SUBMITTAL SUMMARY REPORT MajorSite-000264-2026

PLAN NAME: EFP COMMERCIAL	LOCATION: 3456 SE LAKE WEIR AVE OCALA,
APPLICATION DATE: 01/21/2026	PARCEL: 29884-000-00
DESCRIPTION: THIS PROJECT WILL SUPPORT THE DEVELOPMENT OF AN APPROXIMATELY 18,000 S.F COMMERCIAL FLEX SPACE WITH A MIX OF RETAIL, OFFICE, AND STORAGE USES. THE SINGULAR BUILDING IS INTENDED TO HOUSE MULTIPLE TENANTS.

OCE: Plan Review (DR) v.2

A MAJOR SITE PLAN FOR EFP COMMERCIAL MARION COUNTY Cover Sheet

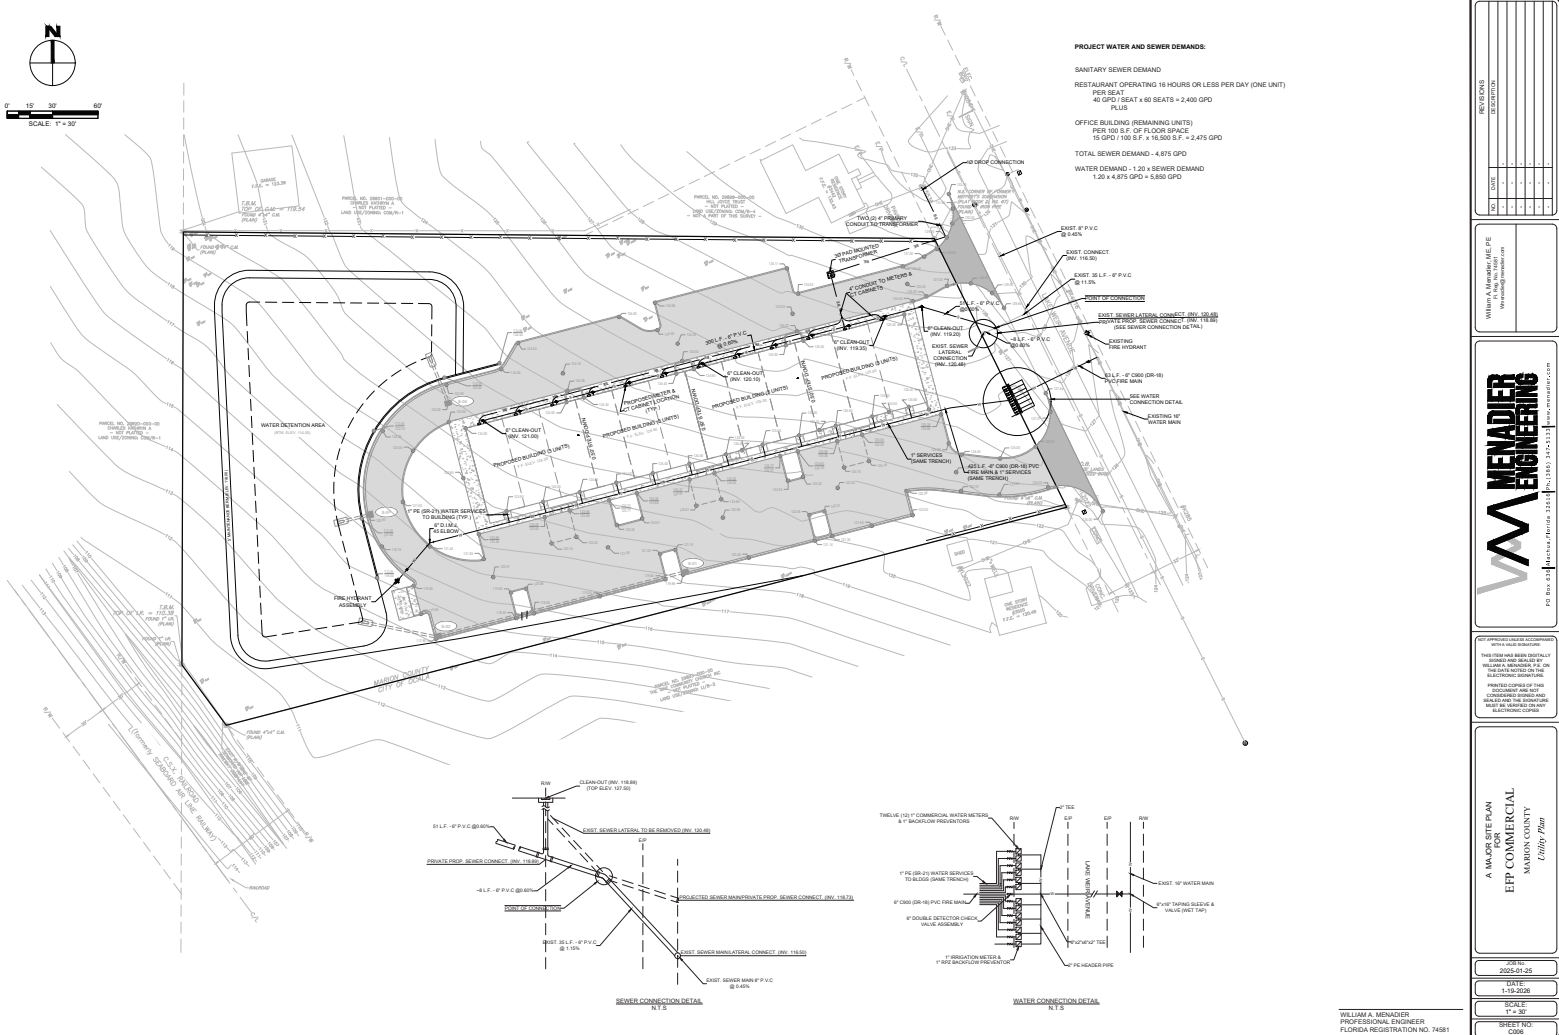
<i>Corrections</i>	2.12 - Rezoning (Resolved) - Corrective Action: Site's correct FLUM and ZONE (COM / B-4) is identified on the cover sheet's site plan data to the right of the site location map. - 2.12 - Rezoning: List of approved Rezoning, case numbers, conditions, and the date of approval.			
<i>Corrections</i>	2.12.4/6.11.7 - Loading area (Not Resolved) - Corrective Action: How will loading/unloading be achieved for the site? This is a concern as the building rear may receive multiple deliveries to service unit occupants (e.g., restaurant and/or retail). Are loading/unloading spaces being provided? - 2.12.4/6.11.7 - Loading area: Show proposed loading areas on plan, per Sec. 6.11.7. - Loading areas.			
<i>Corrections</i>	6.5 & 6.6 - Habitat Preservation/Mitigation (Not Resolved) - Corrective Action: NO: Review pending outcome of the EALS/Exemption documentation and results. - 6.5 & 6.6 - Habitat Preservation/Mitigation: Refer to LDC Sec. 6.6 for requirements and design standards if the site contains open water, wetland, listed species, native habitat vegetation, and/or natural open space. When a proposed development or land clearing site is found to include listed species, the application shall identify species and habitat protection as on-site or off-site. The selected option shall be a condition of approval and shall be completed at time of final inspection.

<i>Corrections</i>	3.2.3 - NON-RESIDENTIAL - Complies with FAR (Resolved) - Corrective Action: YES - Max FAR = 1. Project Data table to right of cover sheet location map lists proposed Building as 18,000 SF on a site of 141,134 SF for a FAR of 0.13 - complies with maximum FAR. - 3.2.3 - NON-RESIDENTIAL - Complies with FAR: For non-residential project, show maximum allowable Floor Area Ratio (FAR) and proposed FAR.			
<i>Corrections</i>	3.2.3/6.6/5.2.5 - RESIDENTIAL - Min/Max Density (Resolved) - Corrective Action: No residential use or development proposed - use identified as "Commercial Flex-space". - 3.2.3/6.6/5.2.5 - RESIDENTIAL - Min/Max Density: For residential project, show maximum and minimum allowable density, and proposed density.			
<i>Corrections</i>	2.12.16/6.5 - EALS or Exemption provided (Not Resolved) - Corrective Action: A document referenced as "Modified Environmental Assessment" has been provided; however the document is a singular letter that does not include any supporting information or analysis as required by the LDC. Revise the document to provide the necessary information - including if the letter is intended to stand as an Environmental Assessment for Listed Species Exemption Request per LDC Sec. 6.5.3. This requirement is NOT eligible for a general LDC Waiver - so either the EALS or EALS Exemption Request as specified by the LDC must be submitted. - 2.12.16/6.5 - EALS or Exemption provided?: Provide Environmental Assessment of Listed Species (EALS) or submit an Exemption (EALS-ER). Copy of the EALS/EALS-ER will be forwarded to review agency for comments. Refer to LDC Sec. 6.5 for submittal requirements and review procedures.

<i>Corrections</i>	2.12.5/1.8.2.F - Concurrency Deferral Statement (Resolved) - Corrective Action: YES - Concurrency deferral statement provided on bottom center of the Major Site Plan cover sheet. - 2.12.5/1.8.2.F - Concurrency Deferral Statement: Please provide a concurrency statement on the cover sheet according to LDC Sec. 1.8.2 (F) - Concurrency Deferral. An owner may elect to defer required concurrency review and approval for a development application identified in Section 1.8.2.A to a subsequent development application review stage by executing the following "Concurrency Deferral Statement" on the development application plan, or in a separate sworn and notarized affidavit, a copy of which shall be provided to Growth Services and the original shall be recorded in Marion County's Public Records, as applicable: "This project has not been granted concurrency approval and/or granted and/or reserved any public facility capacities. Future rights to develop the resulting property(ies) are subject to a deferred concurrency determination, and final approval to develop the property has not been obtained. The completion of concurrency review and/or approval has been deferred to later development review stages, such as, but not limited to, [list subsequent applications expected pursuant to Section 1.8.2.C as applicable]."

<i>Corrections</i>	2.12 - Owner and applicant name (Resolved) - Corrective Action: INFO: The date for the owner and applicant name is on the cover sheet, and the owner and applicant signatures and seals will need to be provided and submitted to complete the Major Site Plan records. Please contact OCE-Engineering for arranging and coordinating the owner and applicant signatures and seals. - 2.12 - Owner and applicant name: Show name, address, phone number, and signature of the owner and applicant on the cover sheet.
